Subject: Crystal River Unit 3
Docket No. 50-302
Operating License No. DPR-72
Environmental Protection Agency 316 Study

NOTES OF CONFERENCE
THIRD QUARTERLY PROGRESS MEETING
FLORIDA POWER CORPORATION

Enclosed is a copy of the Notes of Conference from the Third Quarterly Progress Meeting for the Crystal River 316 Study held in St. Petersburg on May 3, 1984.

temperatures (°C) HWS(2)

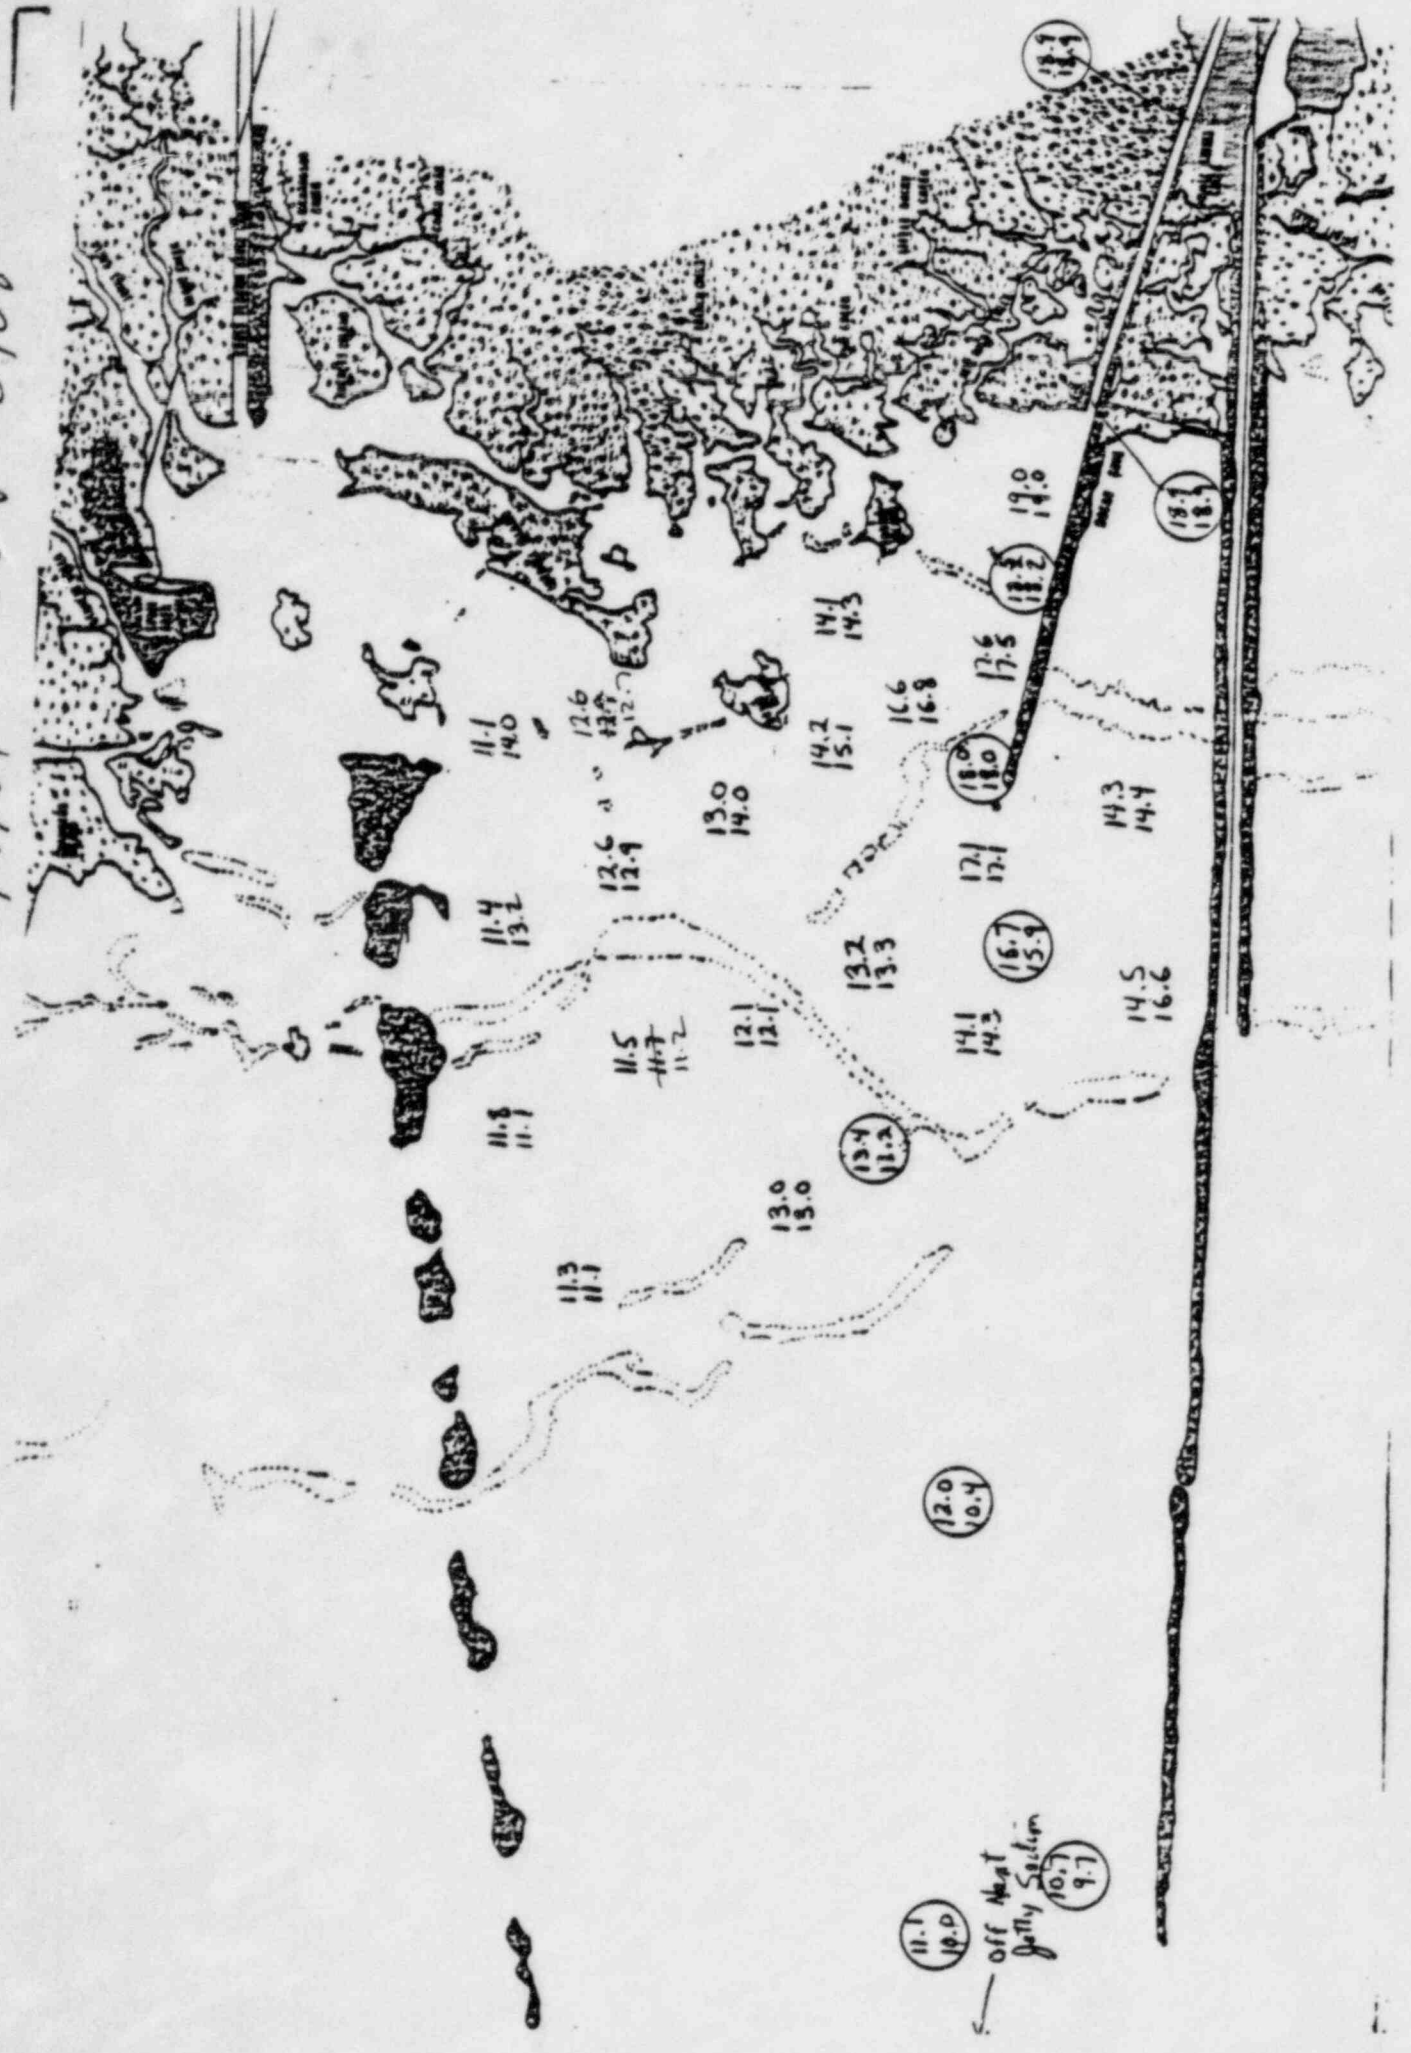
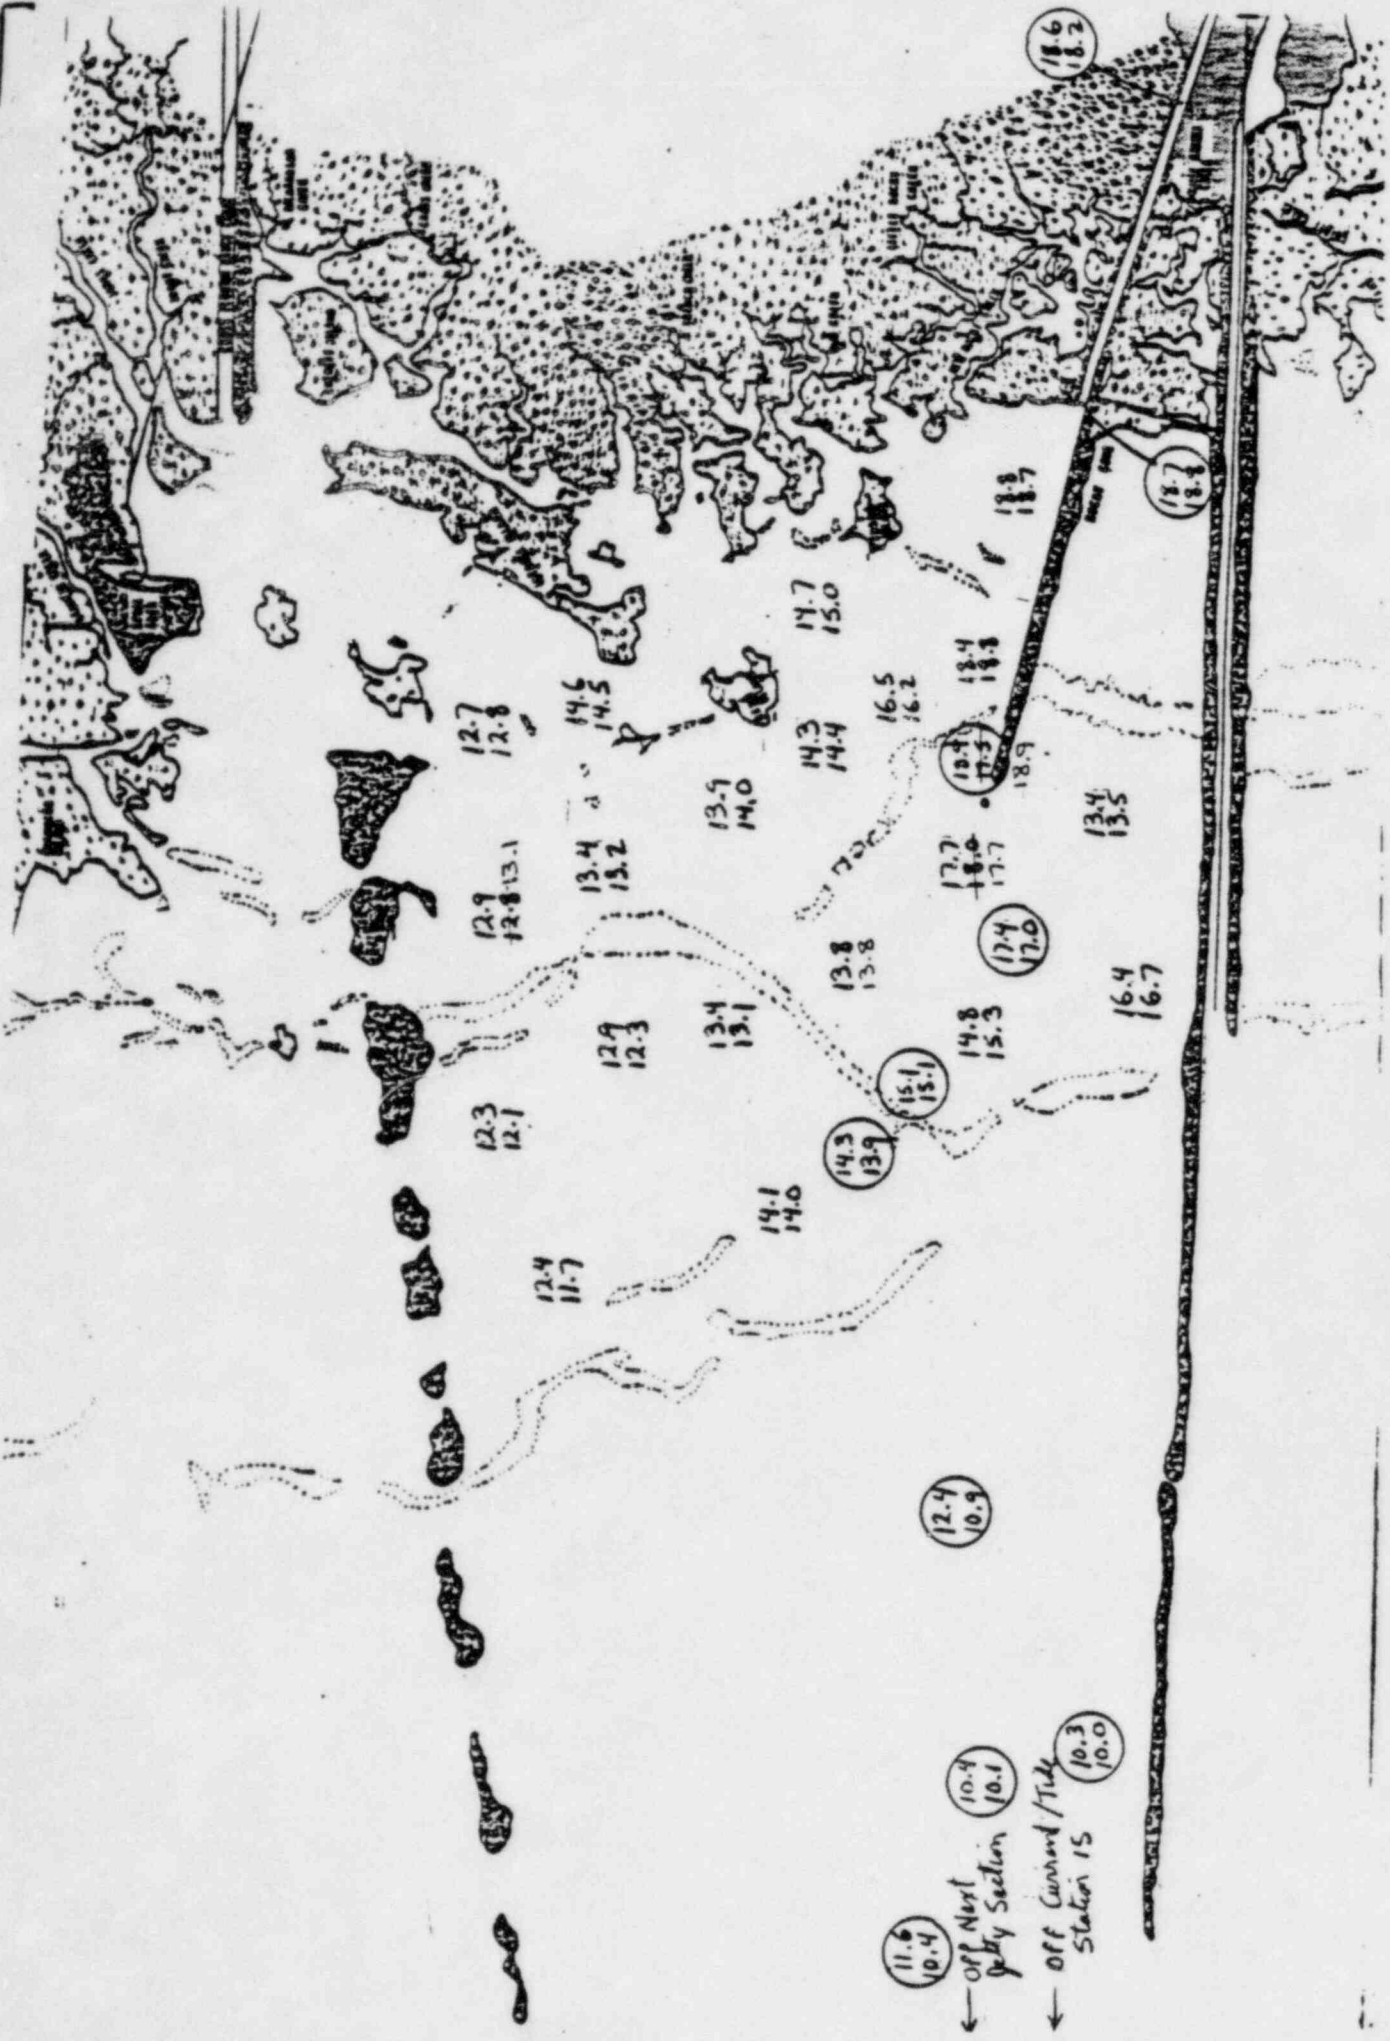
The August and January plume delineation surveys were discussed. Stations were marked by buoys but did vary from one circuit to the next based on tidal conditions, problems locating stations at night, etc. Loran was used to locate stations not at buoys. A map should be provided showing station locations and depths.

There are a few errors in the existing data tables (salt marsh, temperature, entrainment). Corrections were made available at the meeting and marked pages will be sent out shortly. C. Kaplan believes there are still some outliers in the temperature tables and would like to have more information regarding these data including: tidal phase and tide level sampled, station depth, time of tide window, and time of sampling by station.

- Revised tables of June temperature and conductivity. These tables have been changed to reflect a 90 minute, rather than a 2 hour, tide window and to correct incorrectly specified times for maximum tide.
- July, 1984, temperatures by week.
- Juncus marsh data for October, 1983.
- Entrainment densities for July 21, August 31 (2), September 14, and September 27.
- Fourteen figures showing temperatures monitored in August and January. Also, please note that a few uncircled temperatures have been found to represent single readings in contrast to the absolute statement on Page 4-1 of the Quarterly Report, however, they remain uncircled to distinguish the readings from ones taken by the "chase" boat.
